SR 38/US 84 WIDENING
EDS-84(23) and BHN-007-3(25), Clinch/Ware Counties
P.I. Nos. 422120, 422125

Value Engineering Study Report
Preliminary Design Stage

July 2007

re: Project Numbers EDS-84(23) and BHN-007-3(25), US 84/SR 38 Widening and Reconstruction,
Clinch and Ware Counties
Value Engineering Study Report

ALTERNATIVE NO.:
13

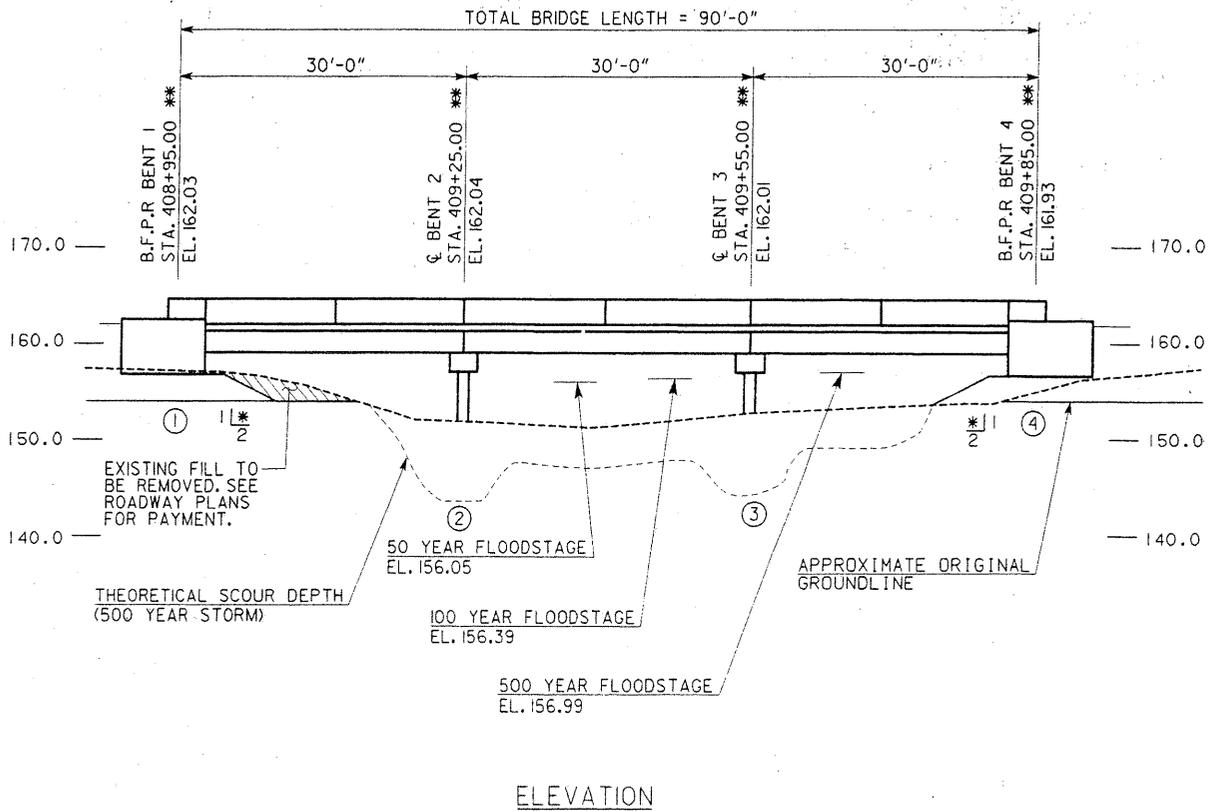
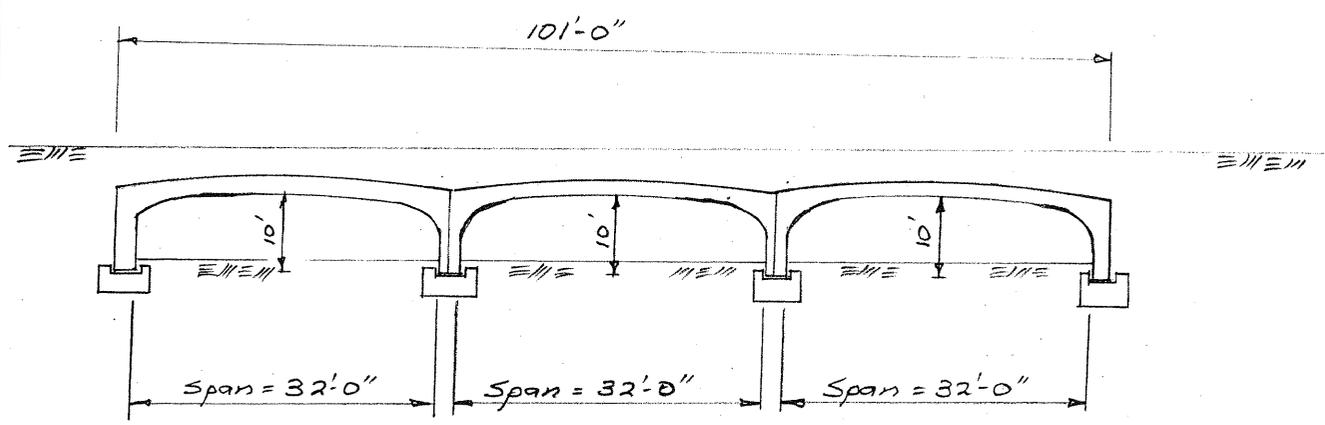
DESCRIPTION: REPLACE THE EXISTING THREE-SPAN BRIDGES WITH
 THREE CONSPAN[®] CULVERTS AT BRIDGE NO. 6 OVER
 LITTLE SUWANEE CREEK

Although Con/Span[®] is addressed with this alternative, other manufacturers are available that can provide similar products.

14

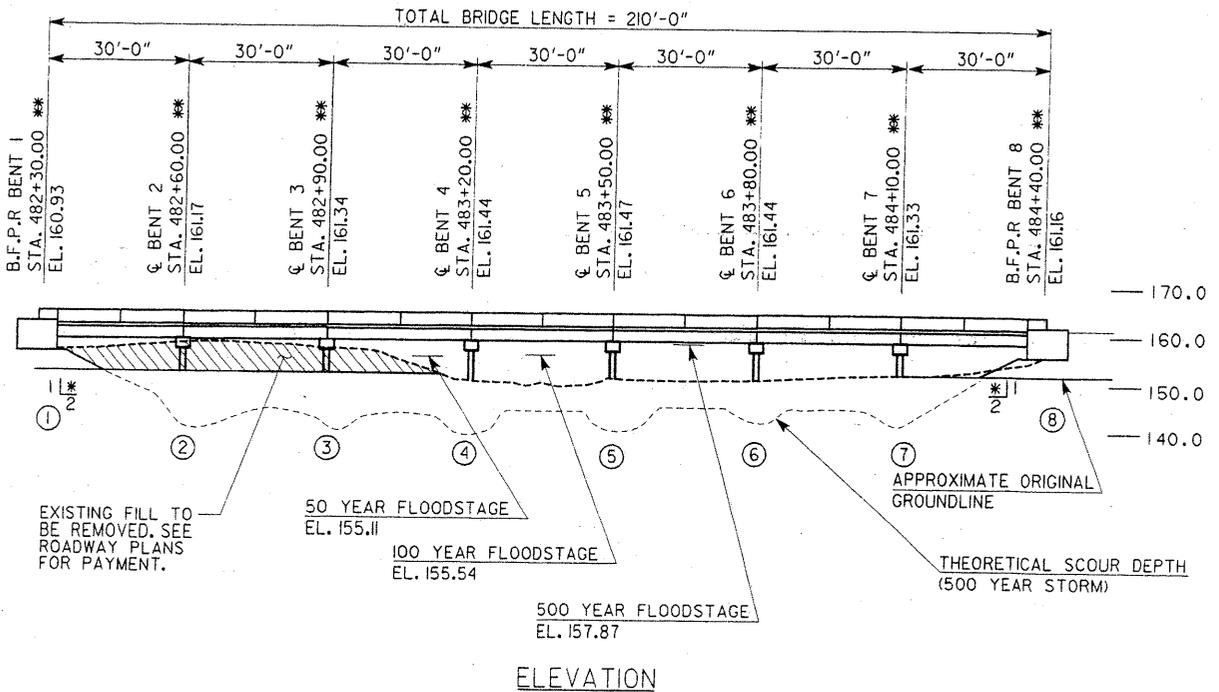
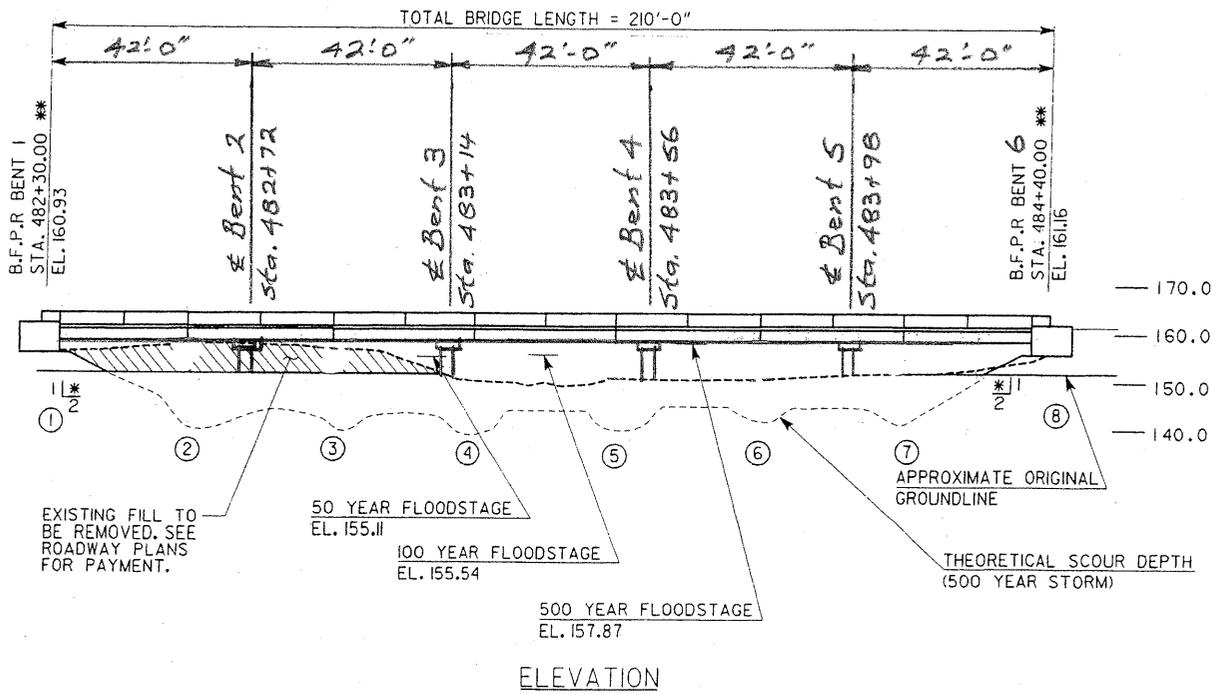
Use five-span (42-ft. each) twin bridge with PSC beams (Type I modified) and pile bents.

Even though it will increase the initial cost to implement this alternative, the duration of construction will be reduced and past records have shown that contractors prefer Type I modified PSC beams vs. T-beams.

15

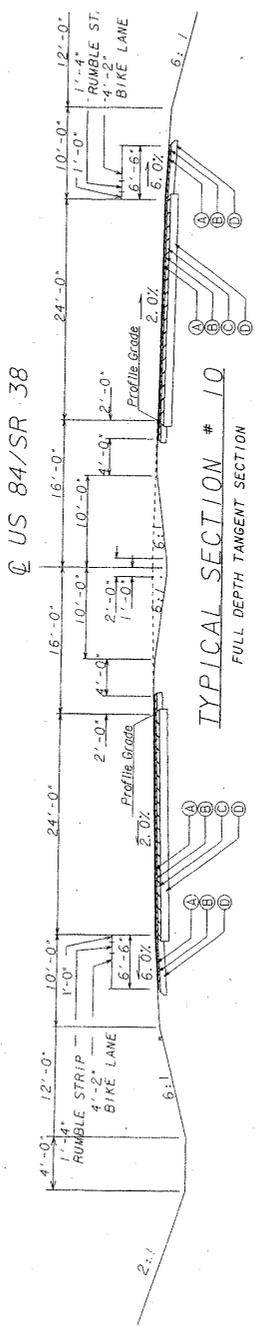
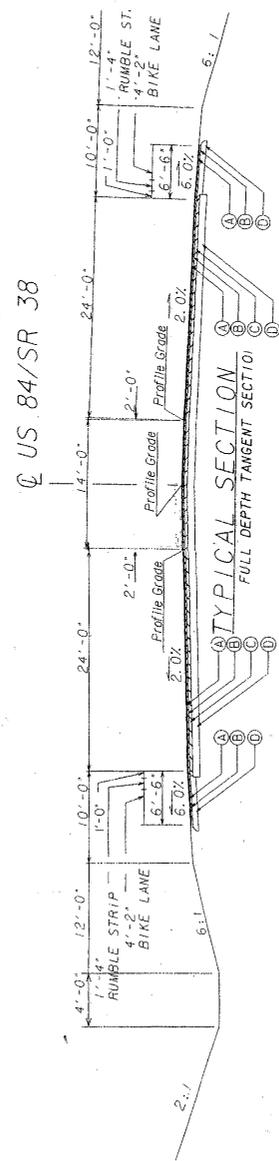
32' median - Rural

14' median - Rural outside
Shoulders

Original R/W (Add'l R/W: 32' - 14' = 18')

$(18' \times 2,682') / 43,560 \frac{SF}{AC} = 1.10 \text{ ac}$ (Add'l R/W 32' med. vs 14' med.)

16

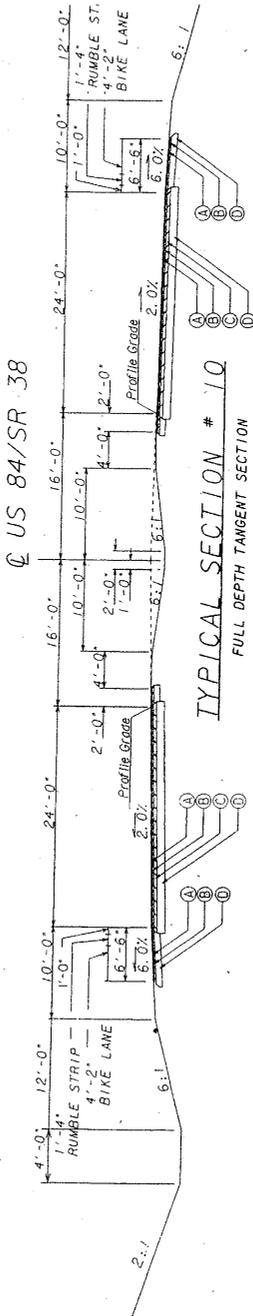
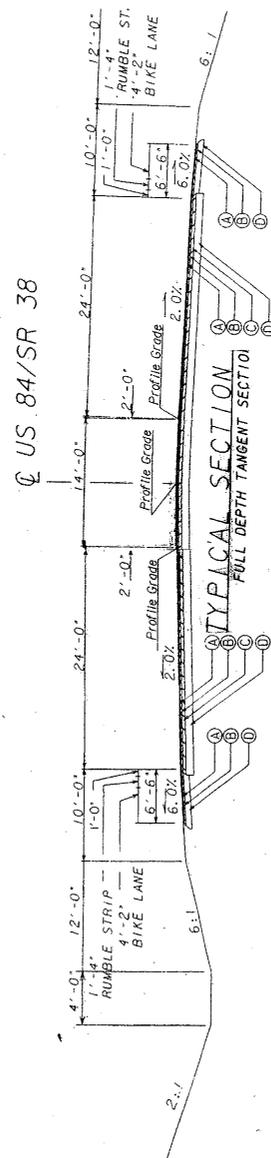
This alternative would continue the 14-ft. paved flush median versus using a 32-ft. depressed grassed median, saving 18 ft. of additional right-of-way costs. The 14-ft. median would provide more accessibility to local residents.

32' median - Rural

14' median - Rural outside shoulders

ALTERNATIVE NO.:
23

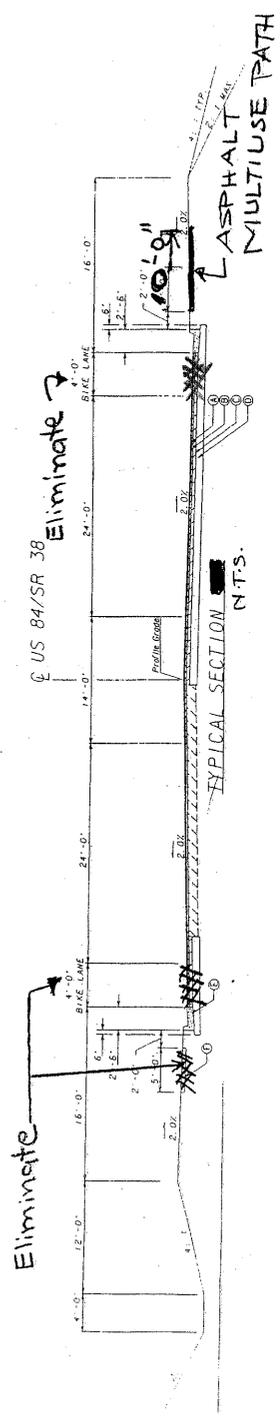
DESCRIPTION: **PROVIDE A MULTI-USE PATH ON ONLY ONE SIDE OF
 MAINLINE THROUGHOUT THE PROJECT LIMIT IN THE
 URBAN AREAS**

The project is predicting an average daily traffic count of only 13,000 in the year 2032. Accommodating full depth pavement for two bicycle lanes and two sets of sidewalks is very expensive and may not be warranted. Known bicycle usage and pedestrian travel is quite limited, and a single multi-use path will provide the necessary functions at a reduced cost.

27

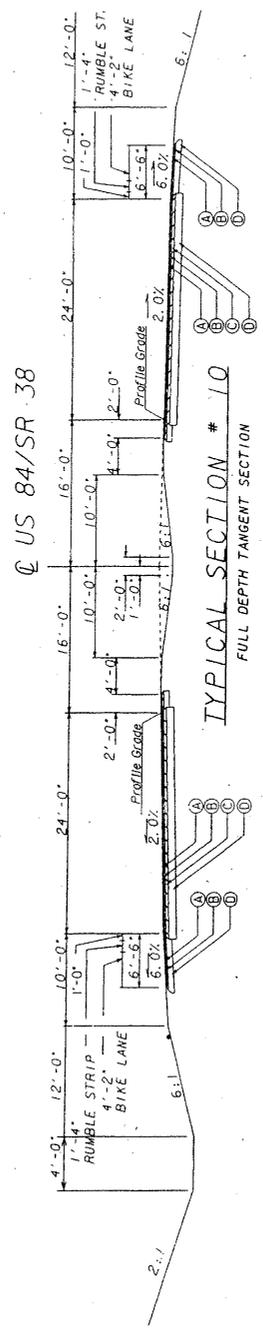
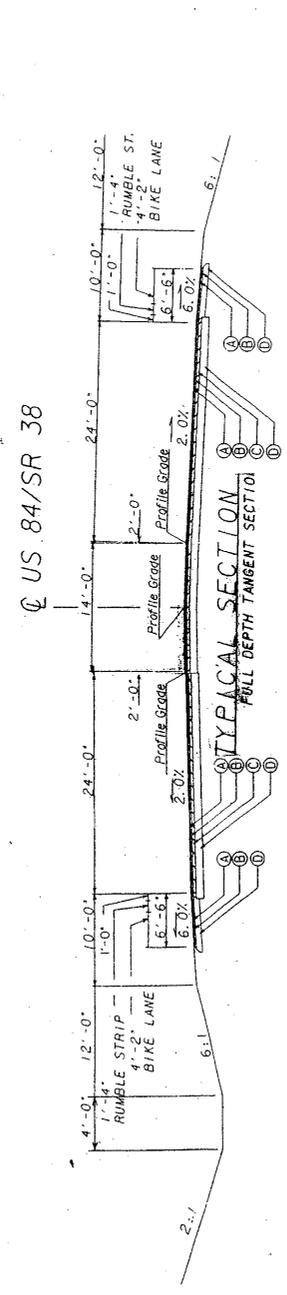
32' median - Rural

14' median - Rural outside
Shoulders

$$\text{Add'l R/W for 32' med: } [(32' - 14') \times (60,300' - 4,960' - 4263')] = 919,386 \frac{\text{SF}}{43,560 \frac{\text{SF}}{\text{AC}}} = 21.1 \text{ AC (Add'l R/W)}$$

30

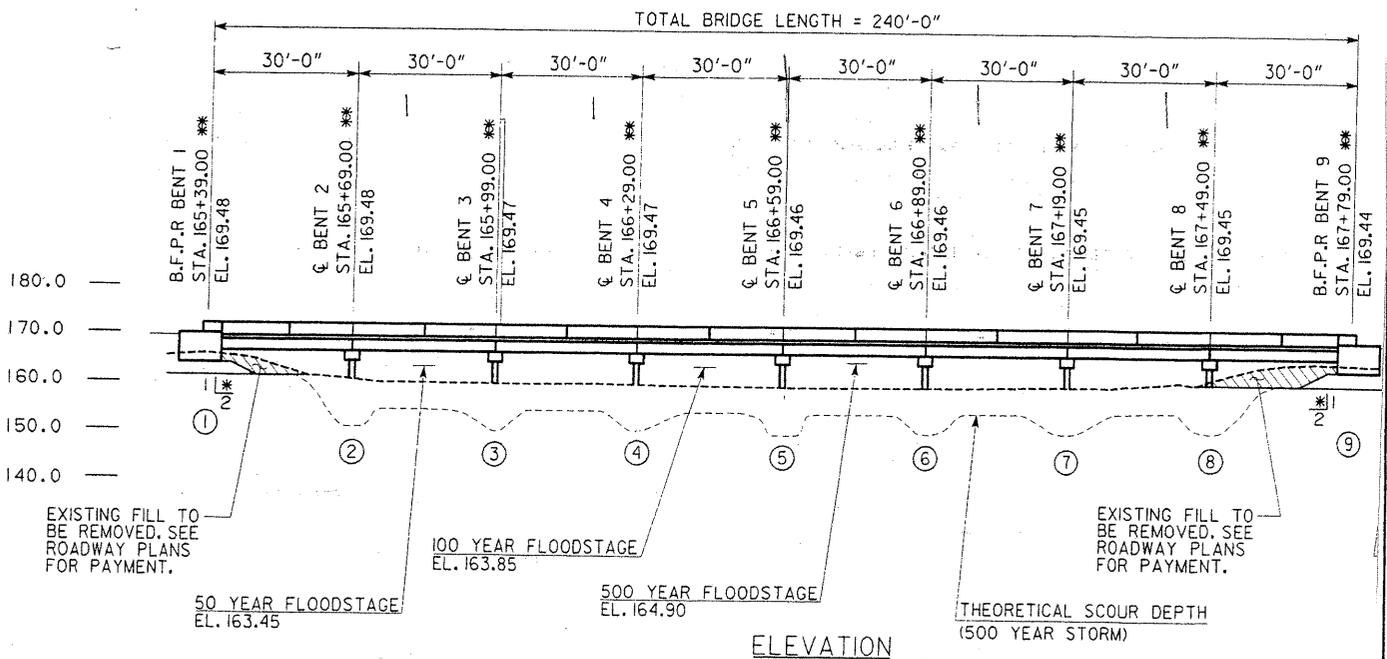
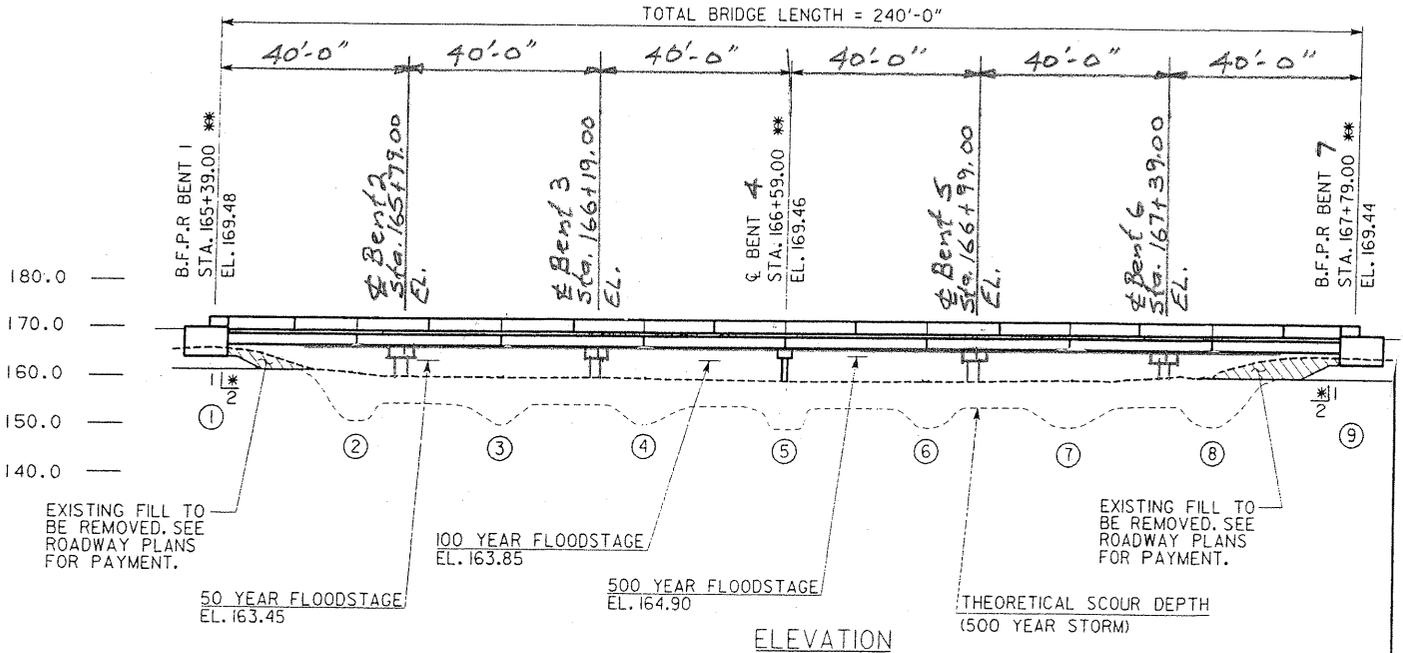
Use six-span (40-ft. each) twin bridge with PSC beams (Type I modified) and pile bents.

Even though it will increase the initial cost to implement this alternative, the duration of construction will be reduced, and past records have shown that contractors prefer Type I modified PSC beams vs. T-beams.

8

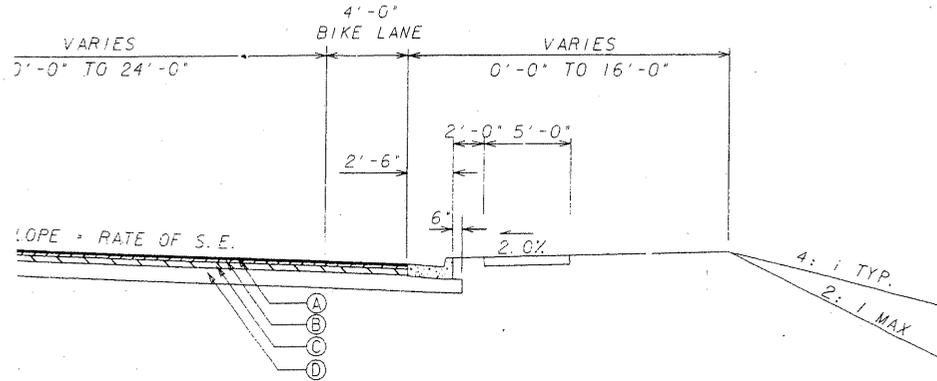
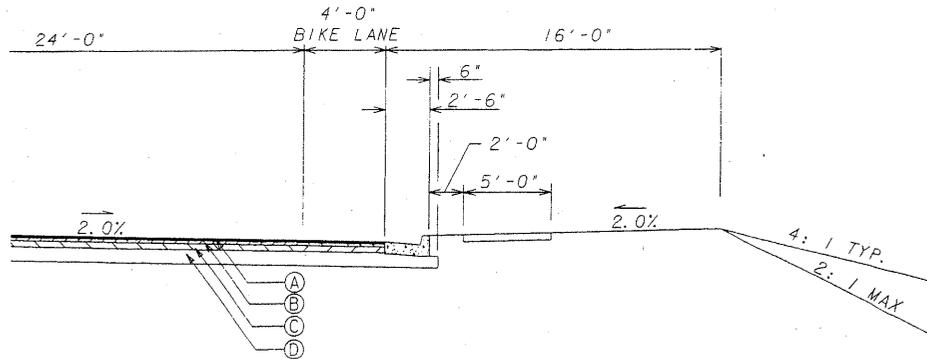
The current cost estimate lists and prices the concrete sidewalk for a 6-in.-thick cross section. The drawing sections indicate the use of 4-in.-thick sidewalks.
